FORESTSIDE TOWNHOUSES

TENDER ADDENDUM # 3

Date: January 31st, 2020

JAP Project No: 19066

Job No: 19066 Sheet No: S-105A

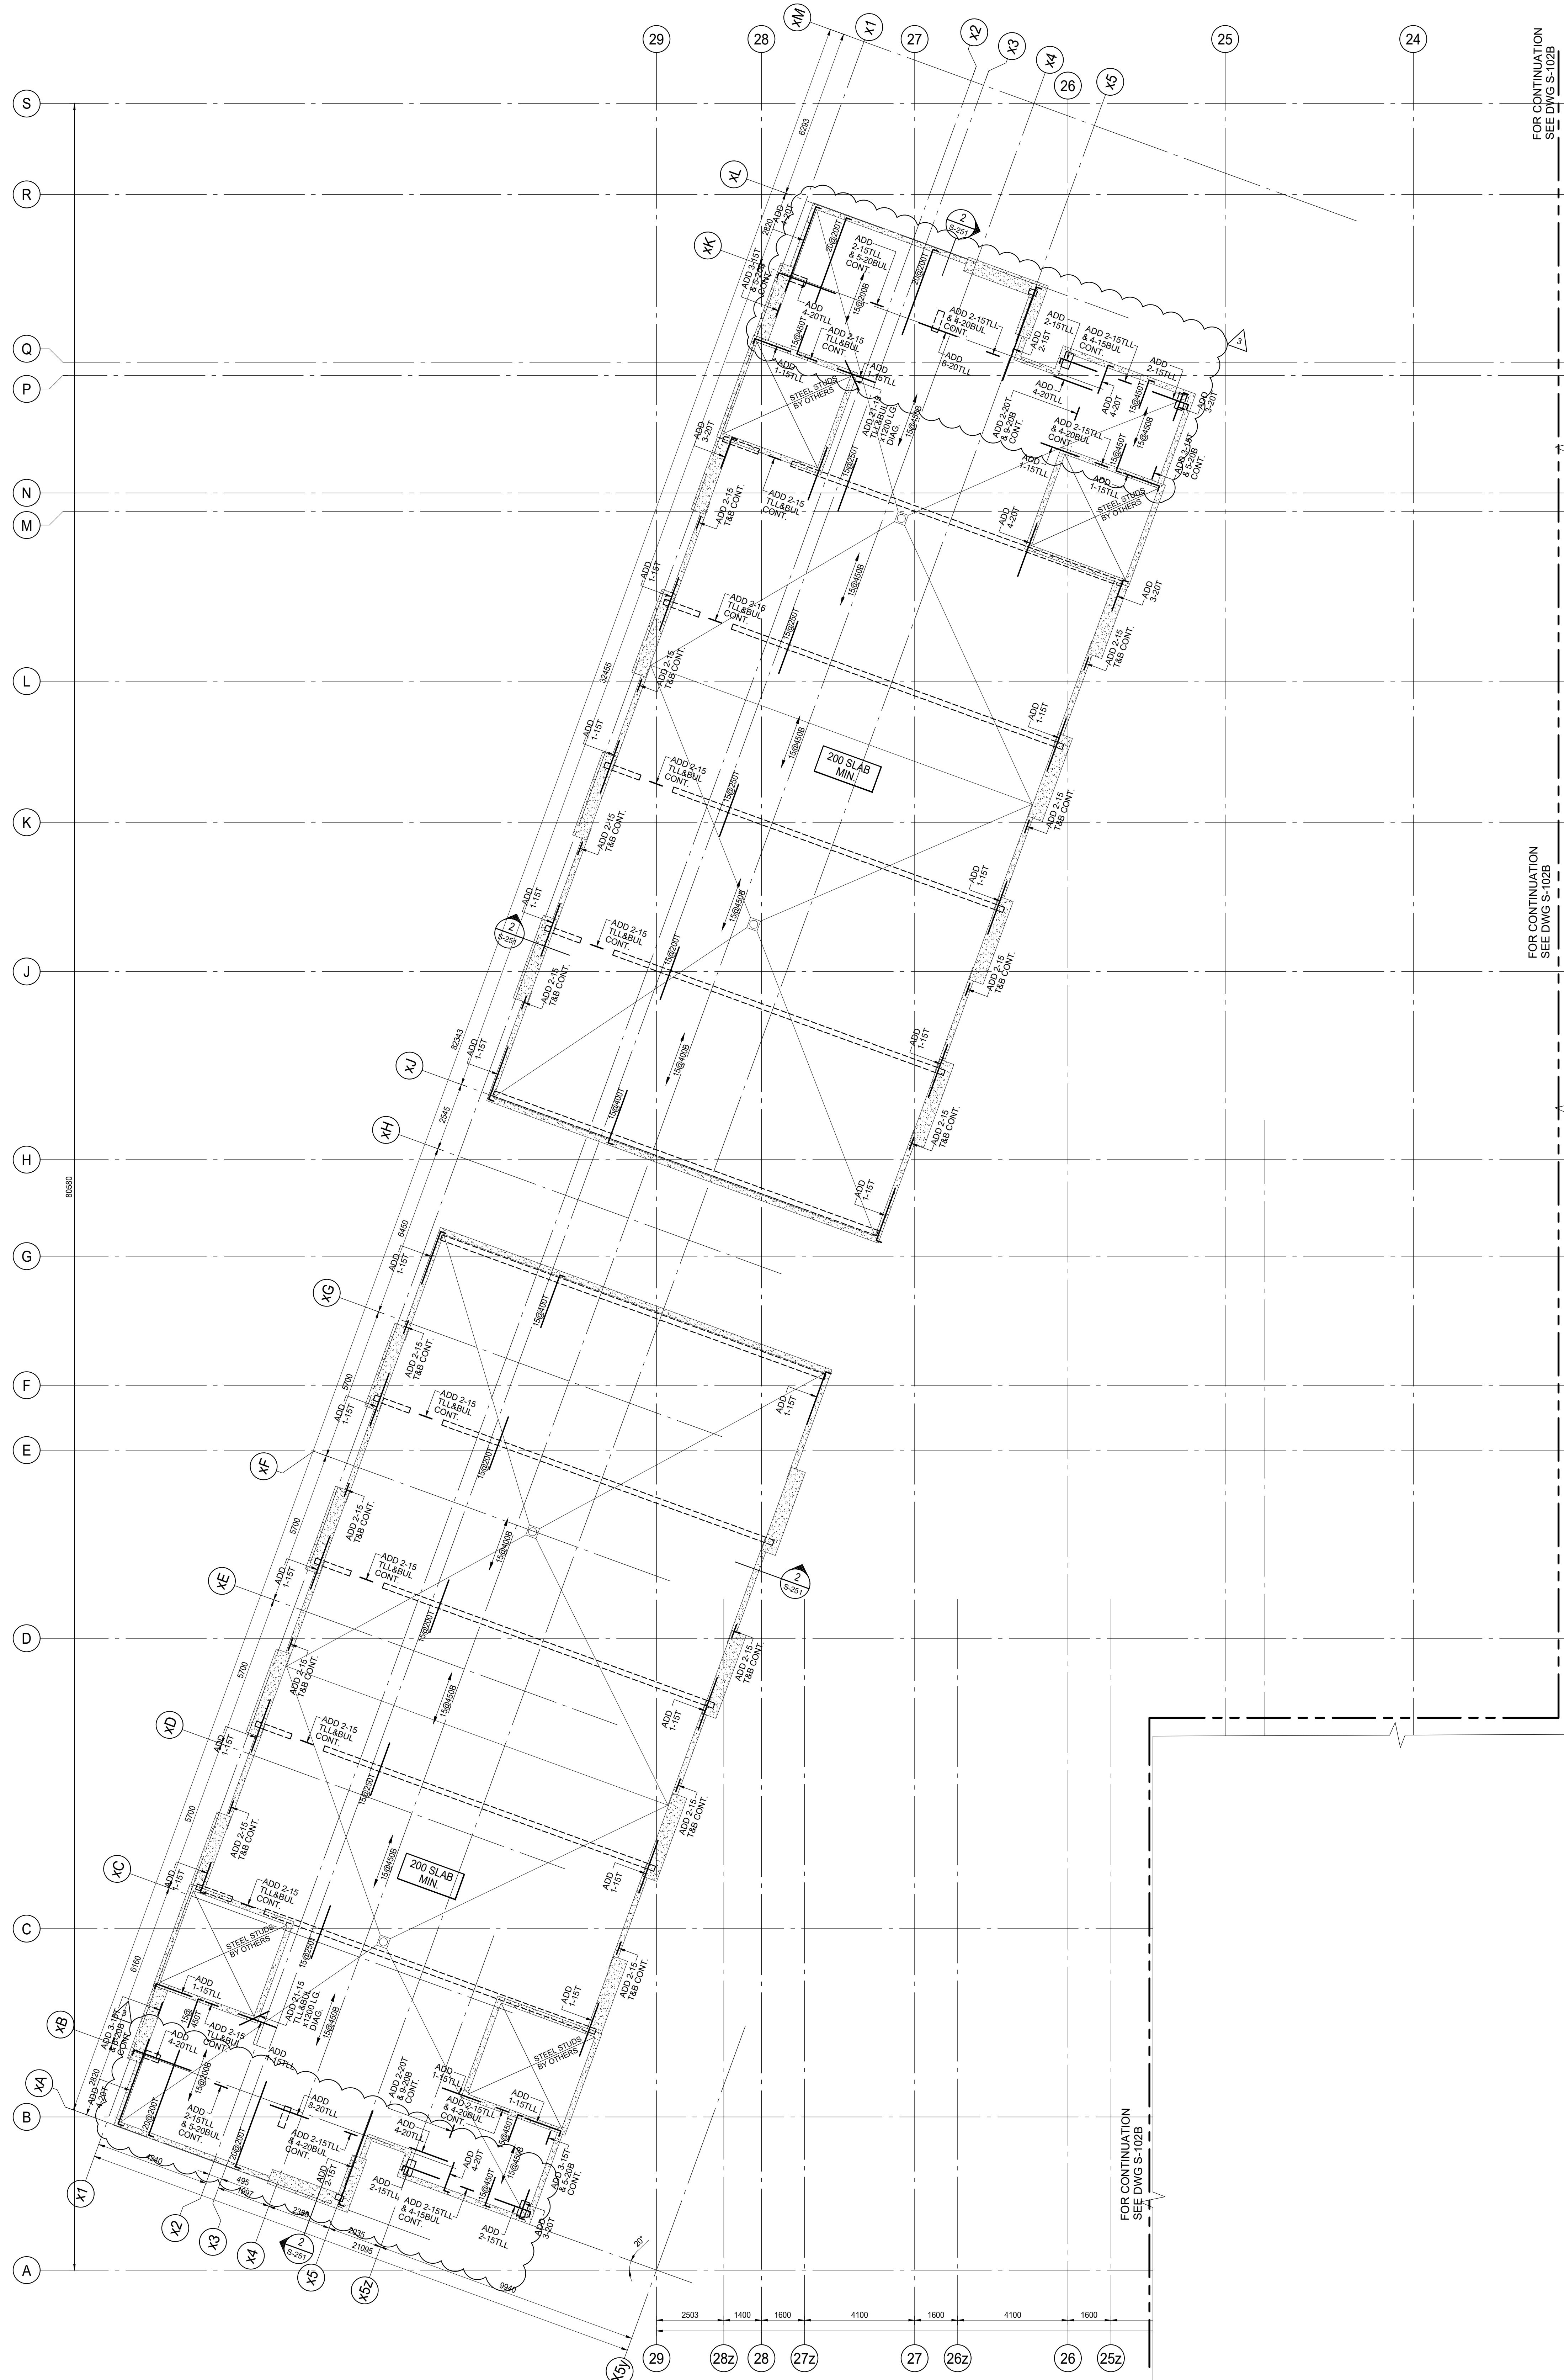
1.5 **Refer to Drawing S-105A & B "4TH FLOOR FRAMING PLAN"**

- l) Structure (column and walls) altered at client request.
- m) Reinforcement at altered structure locations updated.

FLOOR
SECTIONS

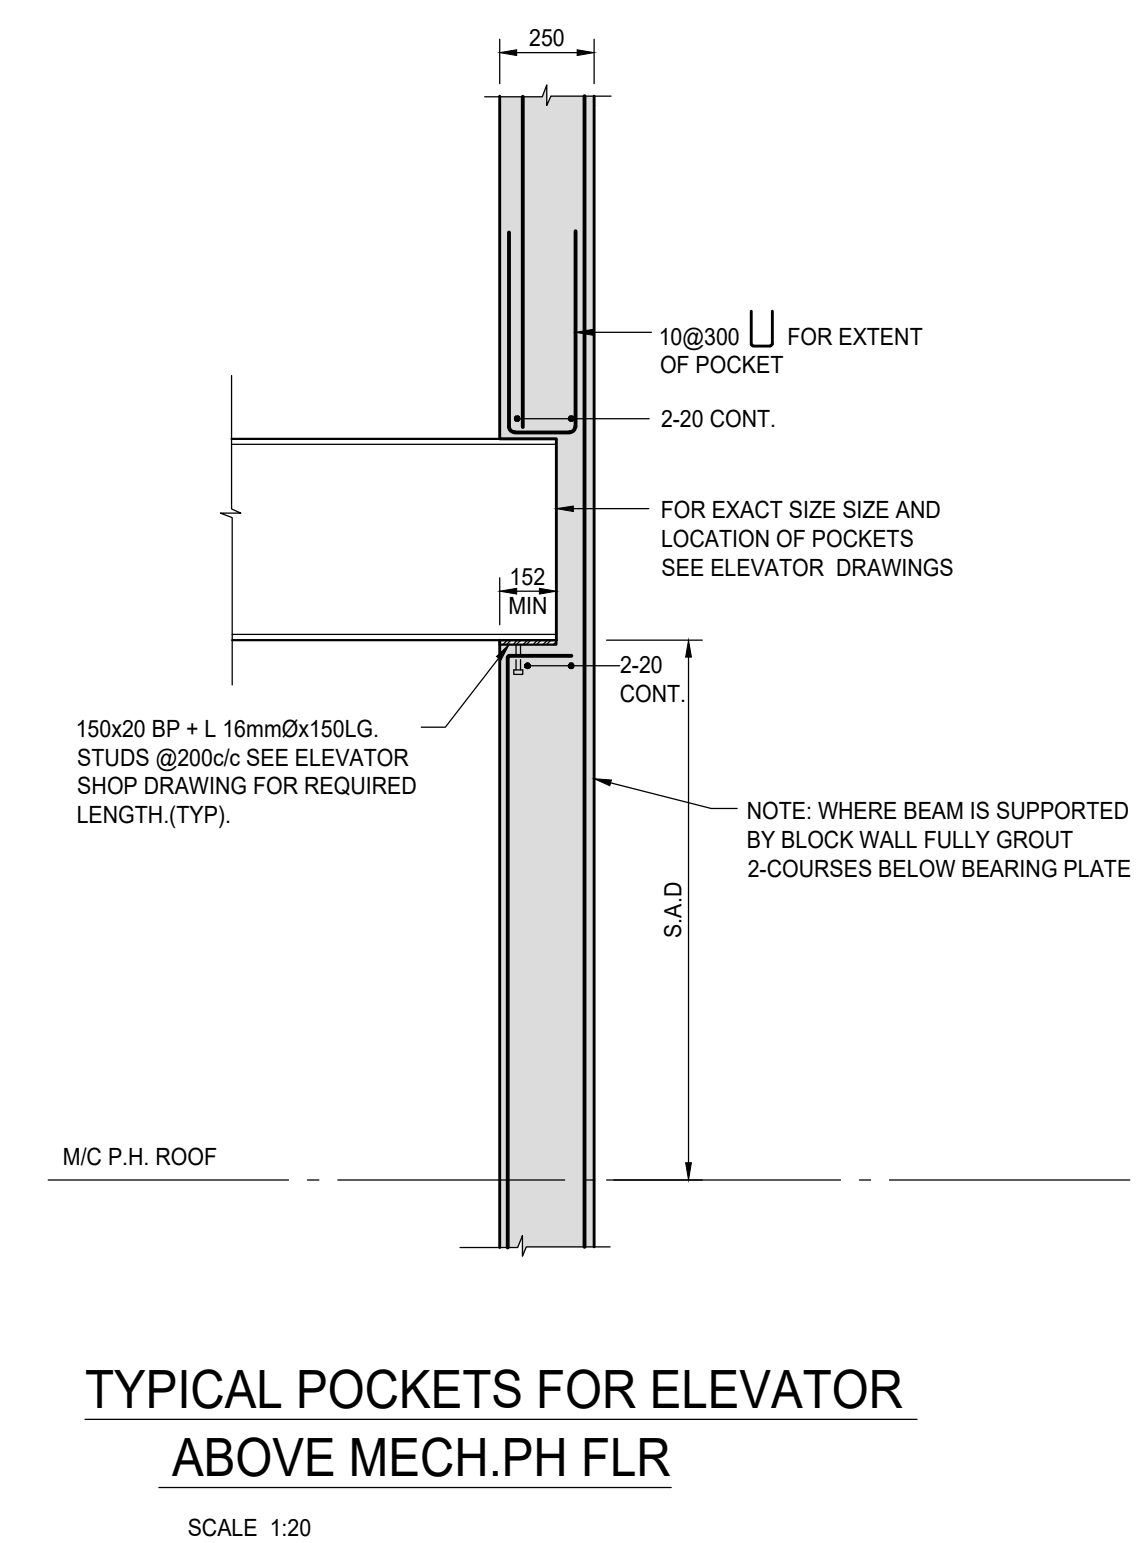
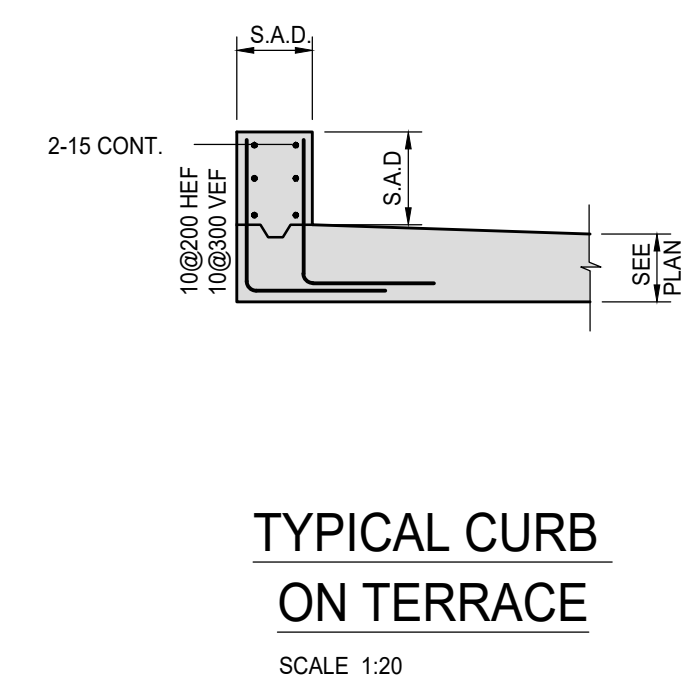
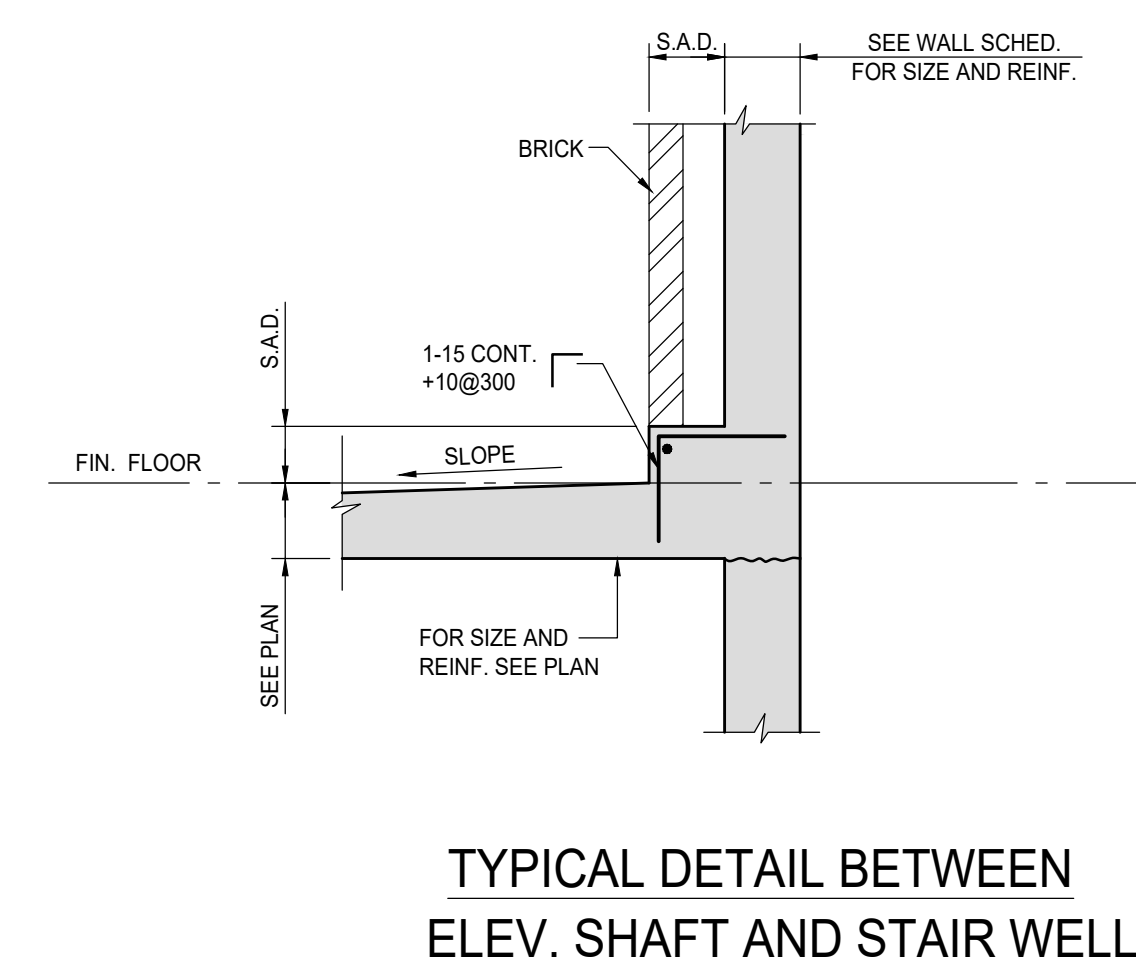
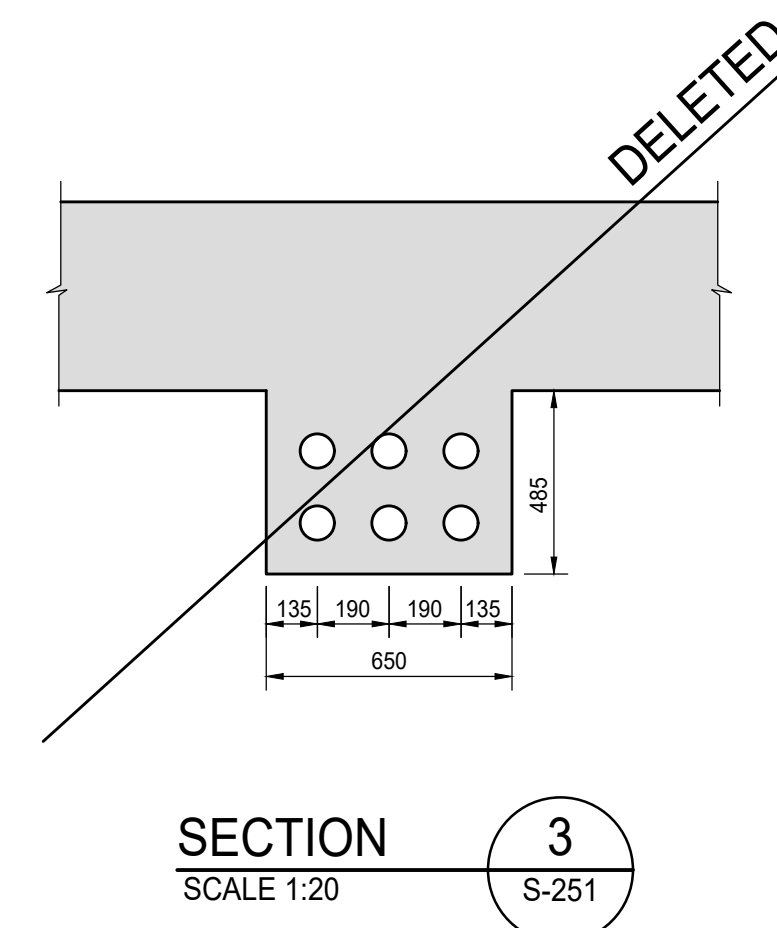
1.7 **Refer to Drawing S-251 "FLOOR SECTIONS"**

- o) Section 2-S251 updated to reflect concrete curb.
